Bombardier Recreational Products Inc.

Date: December 3, 2012

Re: Model Year 2013 Can-Am™ Spyder - Special Repair Needed at PDI

Inspection of the RH side Brake Hose

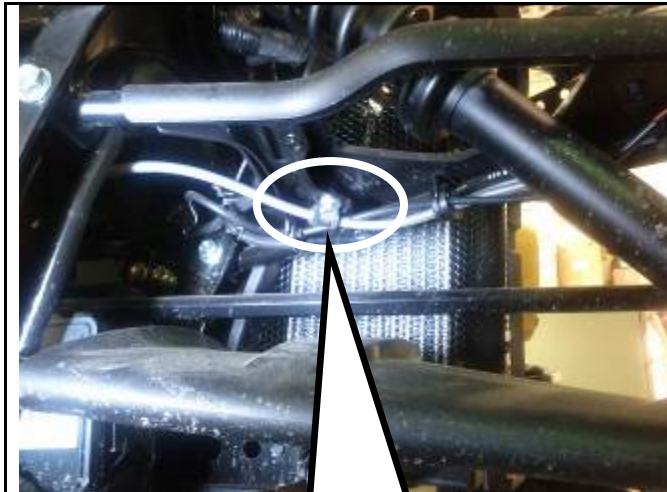
On the RH side of the vehicle, ensure the brake hose is properly secured to the frame; if not, secure it to the frame by inserting the locking tie in the existing hole. Avoid any contact of the brake hose to any sharp edge. Part needed: Locking Tie 368 MM (P/N 293 750 008), qty. 1.

Incorrect Position

Correct Position With Locking Tie

1) Brake hose clamp location

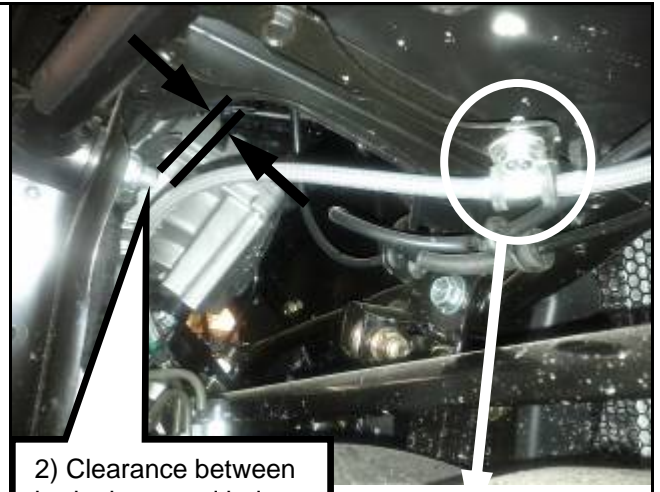
- 1) Ensure the brake hose white mark (the one toward the center of the vehicle) is in contact with the brake hose anchoring bracket rubber piece.
- 2) Ensure there is clearance between the bolt and the brake hose to avoid any contact.

This is the correct brake hose position into the brake hose clamp. If incorrect, loosen the brake hose bracket to relocate the brake hose white mark as shown.

Inspect Wires Routing

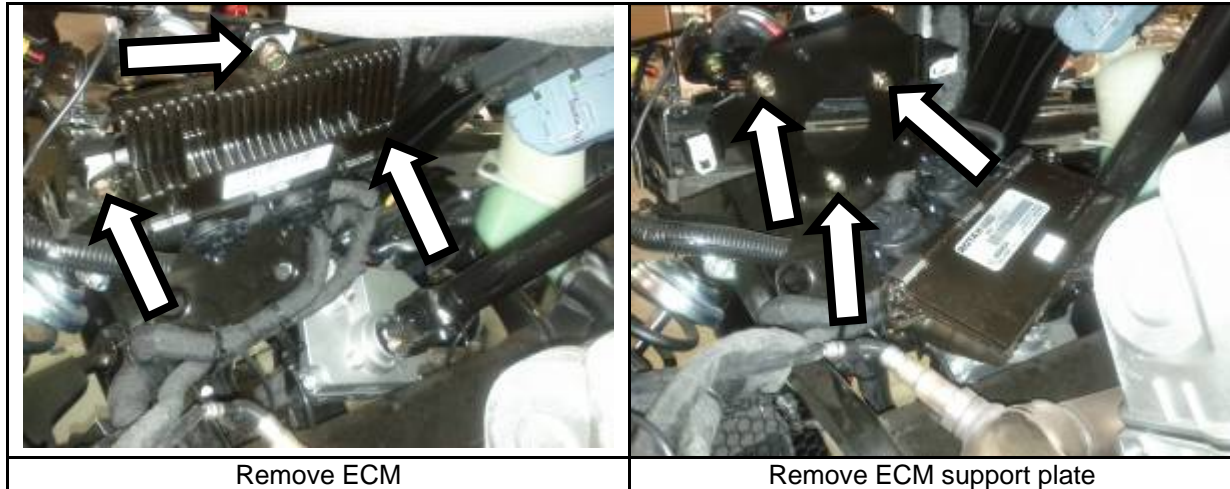
You may see up to 3 wires between the ECM lower anchoring point and the center of the vehicle.

- Red positive cable with corrugated over it
- Regulator/rectifier wires (2) protected by harness tape
- Large black ground cable

Correct Routing	Wrong Routing
<ul style="list-style-type: none"> • Up to 3 wires are visible in the correct area • Each visible wire can be moved slightly with fingers (side-to-side) 	<ul style="list-style-type: none"> • One or more wire is visible in the Wrong Area • One or more wire can not be moved slightly from side-to-side with fingers (must not feel pinched)
<p>No correction needed: reassemble fuse box</p>	<p>Solution: Reroute wire(s), or replace damaged/pinched wire(s).</p>

Repair Wire(s) Routing (if needed)

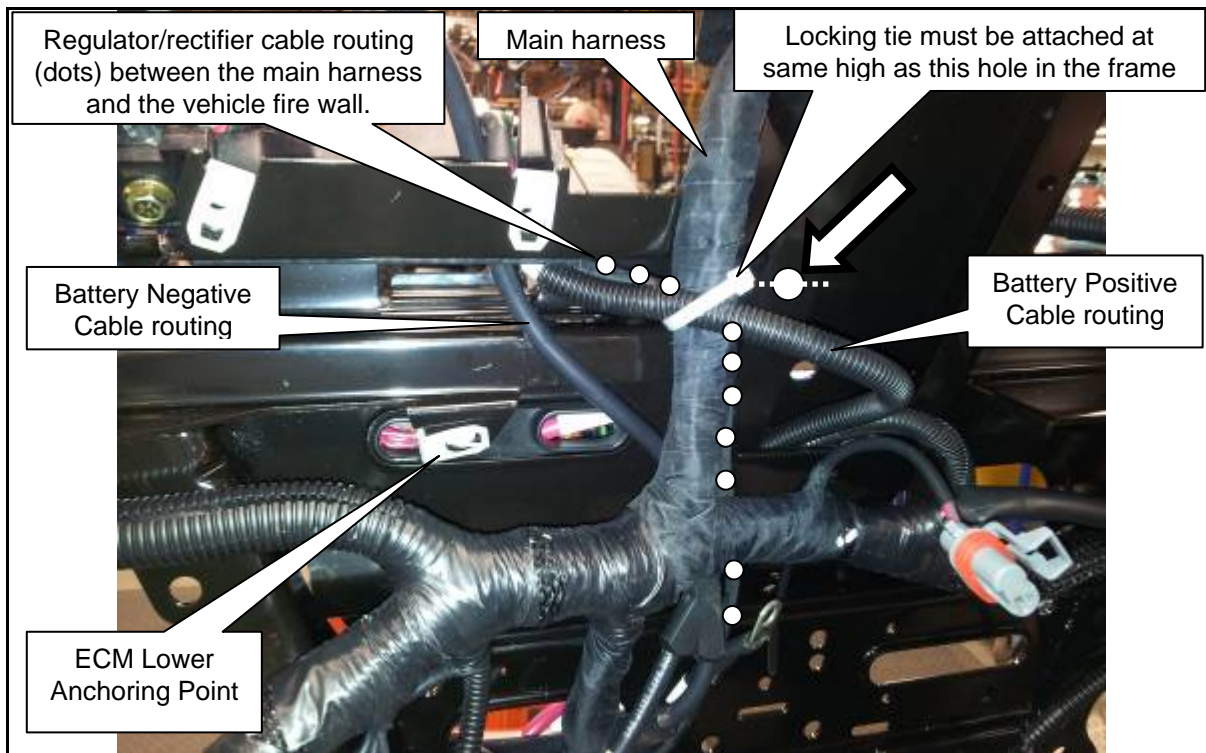
Replace any pinched/damaged wire(s).

Modify routing as per following pictures for (view is from inside of vehicle, looking towards the front):

- Red positive cable with corrugated over it (P/N 710 002 373)
- Regulator/rectifier wires (2) protected by harness tape (P/N 710 002 716)
- Large black ground cable (P/N 710 002 378)

Make sure that all wires are not pinched and routed away from any sharp edge.
Reassemble all components on vehicle.
